# MANDATORY SERVICE BULLETIN

## MSB 42-099/1

## MSB 42NG-035/1

Inspection / replacement of spherical rod end bearing and safety washer of nose landing gear (NLG) actuator, P/N X11-0006/2 with S/N 0155 and below.

1

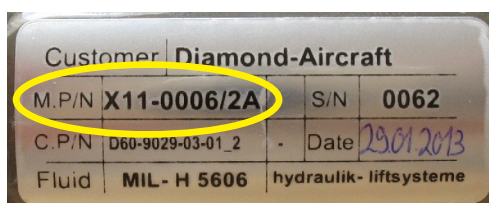
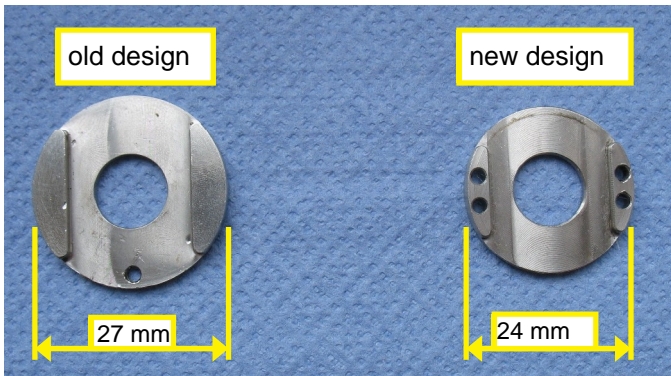
Identify part number (P/N) and serial number (S/N) of nose landing gear (NLG) actuator (use inspection mirror).

safety washer

rod end bearing

NOTE: NLG actuators with P/N X11-0006/2A are not affected by this Service Bulletin.

7	Re-assemble NLG actuator with a new spherical rod end bearing, in accordance with AMM, section 32-30.

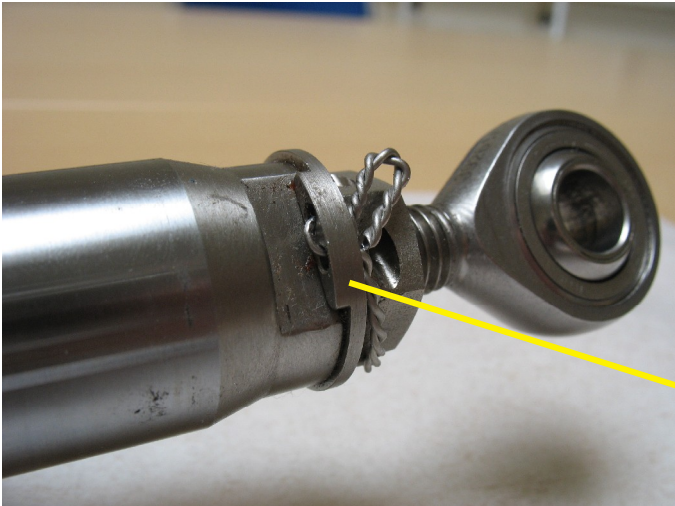
2	If NLG actuator has P/N X11-0006/2 and S/N is 0156 or higher, proceed with item 12.
3	<p>If NLG actuator has P/N X11-0006/2 and S/N is 0155 or lower remove NLG actuator from the aircraft in accordance with AMM, section 32-20.</p> <p>NOTE: It is not necessary to remove the actuator completely from the aircraft. The following work can be done with the actuator remaining connected to the NLG brace assembly and to the hydraulic system.</p>
4	Remove spherical rod end bearing from the NLG actuator piston in accordance with AMM, section 32-30. Discard spherical rod end bearing.
5	<p>Measure diameter of safety washer.</p> <p>Possible diameters are:</p> <ul style="list-style-type: none"> <li>- 27 mm (old design, picture on the left)</li> <li>- 24 mm (P/N X11-0006-00-00.02, Rev B, new design, picture on the right).</li> </ul> 
6	If diameter of safety washer is 27 mm replace it with one of the new design with 4 holes for lock wire and with reduced diameter of 24 mm, P/N X11-0006-00-00.02, Rev B.

8	<p>Secure the counter nut with lock wire. Route the lock wire through both holes on one side of the safety washer, as shown in the picture. Lock wire must not be routed over the circumferential edges of the safety washer as lock wire might reduce clearance between safety washer and actuator attachment lever at the NLG leg.</p>  <p>safety washer</p>
9	<p>Complete information on sticker with date and name of maintenance organization. Clean area of the sticker's size on the NLG actuator with clean and fresh acetone and apply it to the NLG actuator. Cover sticker with transparent protection foil.</p> <div data-bbox="598 1162 1074 1408" style="border: 1px solid black; padding: 5px; margin: 10px auto; width: fit-content;"> <p>modified acc. to <b>MSB 42-099 / MSB 42NG-035</b> Safety Washer replaced by P/N X11-0006-00-00.02, Rev B Date: _____ Name: _____</p> </div>
10	Reinstall NLG actuator in accordance with AMM, section 32-30.

14

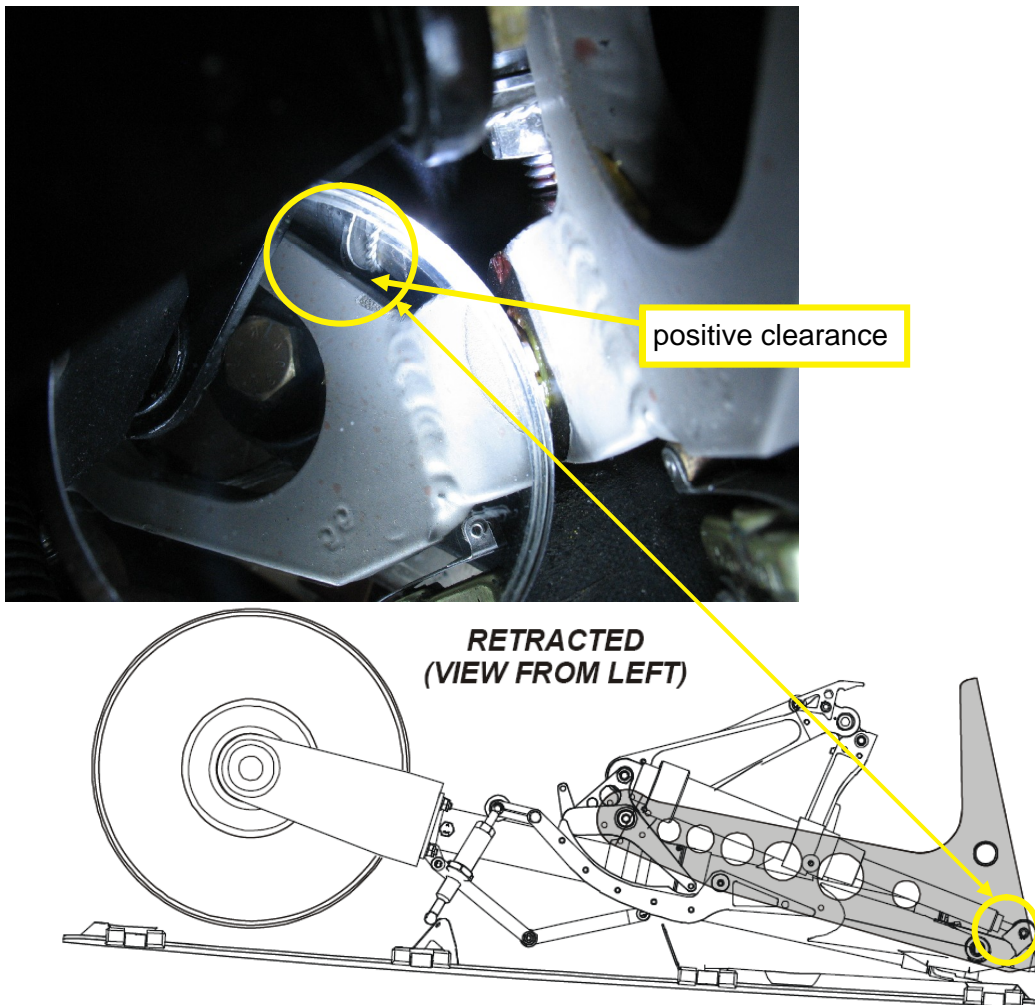
Carry out a landing gear extension and retraction test in accordance with AMM, section 32-30 and check for positive clearance between NLG actuator safety washer and actuator attachment lever at the NLG leg when the landing gear is retracted (use inspection mirror).

If there is no positive clearance between NLG actuator safety washer and actuator attachment lever at the NLG leg, check adjustment of NLG actuator length according to AMM, section 32-20. In case no positive clearance can be adjusted, contact Diamond Aircraft Industries GmbH.
